RE: CLARIFICATION AND RESPONSE CIRCULATION NO.1

NOTICE TO TENDERERS

<u>CLARIFICATION</u>	
<u>CONTRACT NUMBER:</u>	JW 13897
<u>CONTRACT TITLE:</u>	Northern Wastewater Treatment Works Expansion of Capacity Unit 5 – Phase 2 (Mechanical and Electrical Works)
<u>DEPARTMENT</u>	JW- SCMU
<u>Email</u>	thapelo.teane@jwater.co.za and nthabiseng.matabane@jwater.co.za

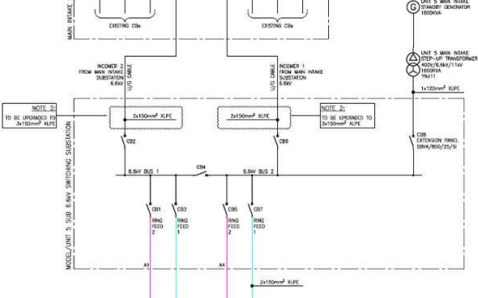
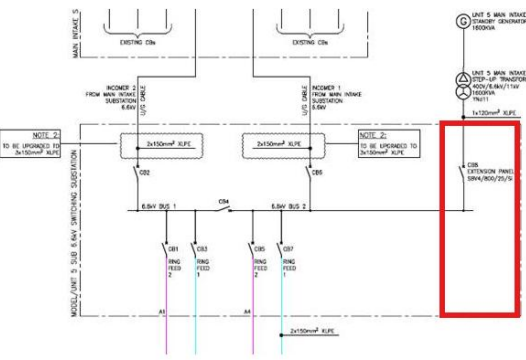
<ol style="list-style-type: none"> Is the image above for the existing Unit 5 Module 1 MV reticulation? If so then this board would be the Actom Board if I am correct where we will tie in the Actom Generator Panel to the existing board. I don't see a single diagram drawing for Unit 5 Module 2 in the drawing pack. Please can this be provided. The MV board also requires 2 Isolators and 4 feeders. Would this not be a ring main unit? There are also no specifications as to what the amperage should be and the other boards are all 6.6kV but the new board is 11kV. Will the 2 Isolators behave like 2 incomers and what are their 	<p>The image above represents the existing MV switchgear panel with 4 outgoing feeders CB1, CB2, CB5 and CB7, CB8 the Generator Extension Panel will tie into the existing board as indicated in the indicated in the image below.</p>  <p>The Single line diagram for the Bioreactor for Module 2 was included in the tender documents the drawing number is JW13021R-5E2-SM01. It has been Reattached your reference. The portion highlighted in RED is the extension from the generator Step-up portion. The board is an Actom SBV4 MV switchgear.</p> <p>There are no existing RMUs present currently. This will be an MV Switchgear. The respective datasheet for the Unit 5 Module 2 MV Switchgear has been attached for your information.</p> <p>Refer to Datasheet JW13898-E-007-1 MV Switchgear.</p>
